Author's response

High-resolution vertical biogeochemical profiles in the hyporheic zone reveal insights into microbial methane cycling

Point-by-point response to comments of Carsten J. Schubert

Point-by-point response to comments of Anonymous Referee #2

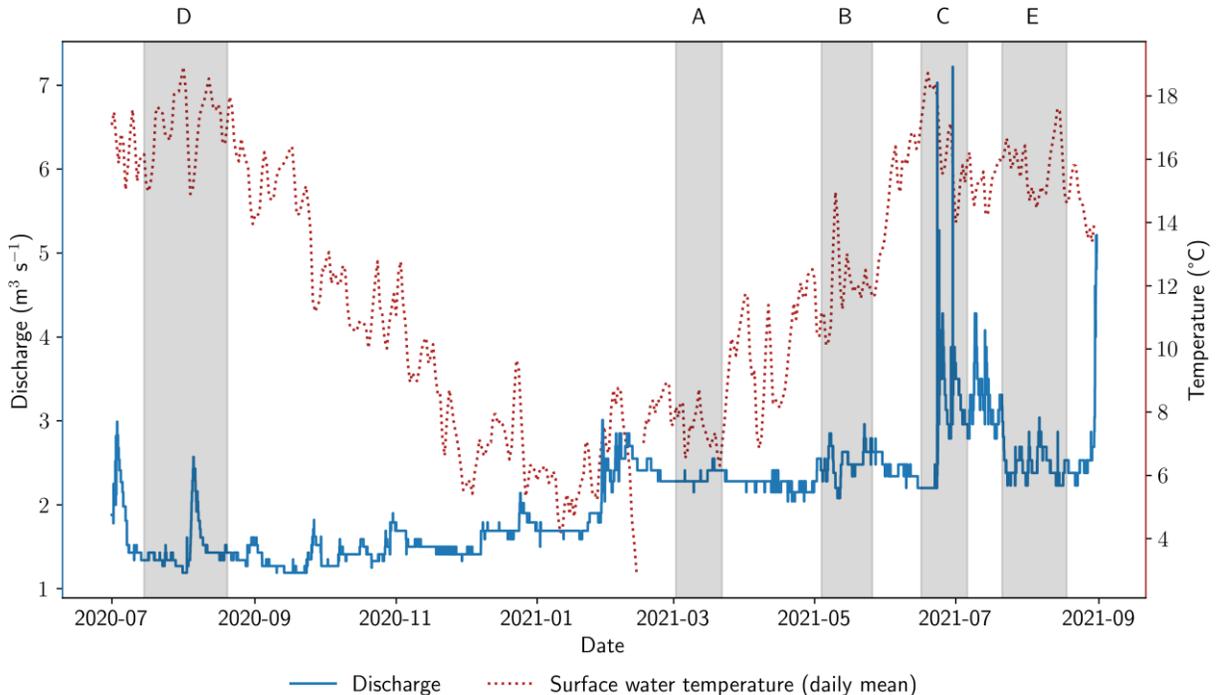
1. Peepers integrate over long periods. I am not fully convinced that using them in a highly dynamic habitat is the best choice. Also the interpretation of the profiles relies on steady state assumptions. In order to judge this, it is necessary to have more information about temporal dynamics in that stream. I suggest to improve Figure 1 by showing discharge data with high temporal resolution (at least daily means) and to indicate peeper deployment periods in the figure. That enables judgement whether e.g. a flood occurred shortly before peeper retrieval. I think only stable conditions during peeper deployment allow the presented interpretation of the profiles.

L.118: That information cannot be seen in Figure 1. Give discharge data with high temporal resolution.

Figure 1 has been updated to show discharge data with a higher temporal resolution and sampling intervals (see below). Generally, the study site at river Moosach shows very low flow variability and low sediment dynamics compared to other rivers. The discharge is completely controlled by weirs and check dams leading to stable hydrologic conditions. Further, fine deposits with low hydraulic conductivities dominate this river segment resulting in reduced hyporheic exchange. After sampling at river Moosach for several years we know that patches of coarse and fine sediment are stable for long time periods. In summary, the system is not as dynamic as the hyporheic zone often is and as the reviewer has probably assumed for river Moosach. The updated Fig. 1 supports this. Only during the sampling period at site C, two peaks of more than $6 \text{ m}^3 \text{ s}^{-1}$, classified by the GKD Bayern as mean flood discharge, occurred. This actually is an interesting information, because the higher discharge might be responsible for the infiltration of increased amounts of O_2 and NO_3^- and thus, could be an explanation for the observed CH_4 consumption in this profile. We included this argument at two points in the discussion:

“For example, extreme events can alter the chemistry of infiltrating surface water, as well as hyporheic flow path lengths and residence times, thus impacting hyporheic geochemistry in multiple ways (Zimmer & Lautz, 2014). In this study in particular, location C might have been impacted by two high flow events during the sampling period.” (L. 387-390)

“One reason for the observed methane oxidation in location C could be an increased supply of O_2 and NO_3^- during the two high-flow events in the sampling period.” (L. 442-443)

Please check the updated Fig. 1.

Figure D1: Correlation between CH₄ and NH₄⁺. Each panel corresponds to one measured profile. Axes are scaled in the range of the data. For profiles C and D, a linear regression was performed and R² values are given in the respective plots.”

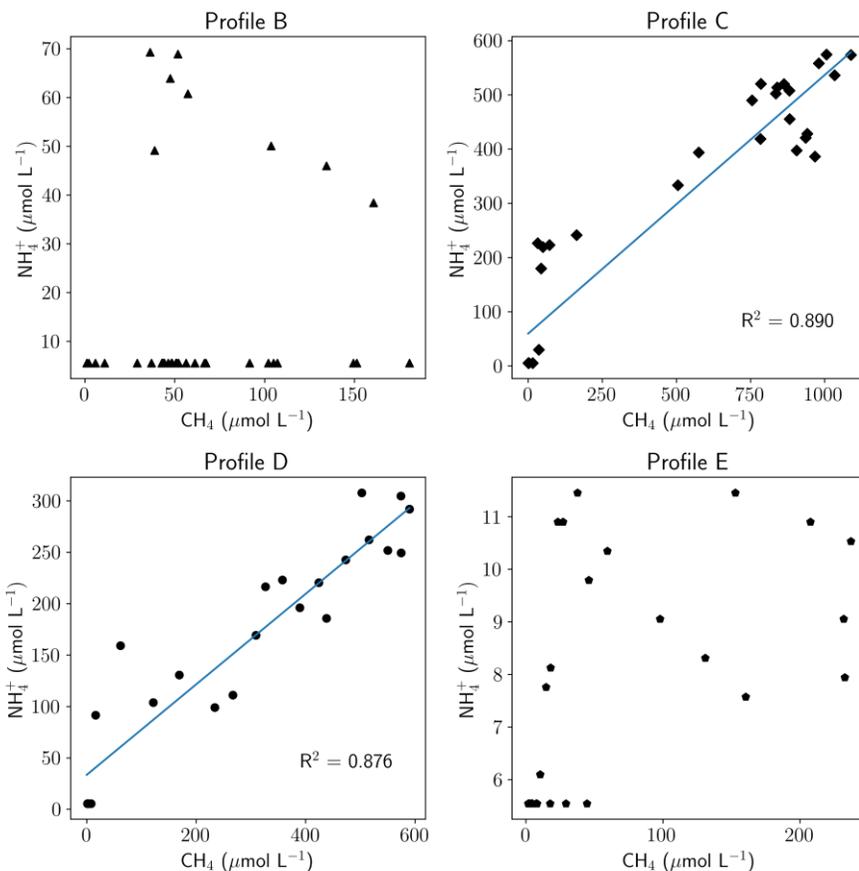
L.334: Can you show the correlation between CH₄ and NH₃, e.g. in the supplement?

Scatter plots of CH₄ and NH₄⁺ concentrations have been added as Appendix D. This has been integrated into the paper as follows:

Figure D1 shows the correlation between CH₄ and NH₄⁺ concentrations. In profile A, no NH₄⁺ could be detected, therefore only data for profiles B-E is displayed. A clear positive linear correlation can be observed for profiles C and D. In profile B, NH₄⁺ was mostly below the detection limit of 0.005 mmol L⁻¹. Higher concentrations were only found between 6-14 cm depth, above the zone where CH₄ concentrations peaked (increased CH₄ concentrations between 5-23 cm depth with a peak at 15 cm depth). A negative correlation between CH₄ and NH₄⁺ concentrations seems to exist between 6-14 cm depth. In profile E, no correlation can be observed, NH₄⁺ concentrations are generally very low compared to the other profiles.
